**Chemung County Stormwater
Construction Inspection
Erosion and Sediment Control**

Project Name Scotch Pine Lane Housing Development	Date 9-4-18
Location Scotch Pine Lane Horseheads, NY	Permit # NYR11D756
Weather Conditions Sunny, hot, humid	Entry Time: 11:17 am
On-Site Representative Present: None	Exit Time: 11:30 am

PROJECT: Scotch Pine Housing Development
Town of Horseheads
Municipal Construction Inspection
September 4, 2018

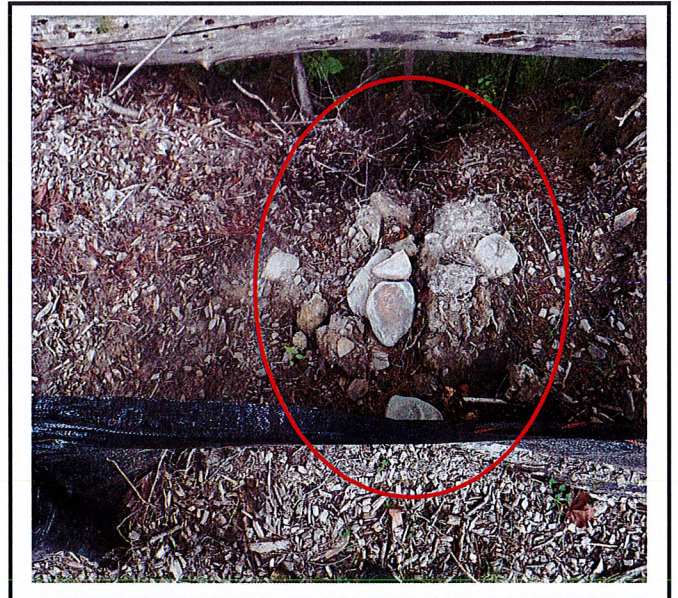
Construction entrance in place but mud is being tracked into the road.

Areas behind house open with no stabilization.

Silt fence still requires attention.

Water went over the silt fence and is causing erosion down to the stream.
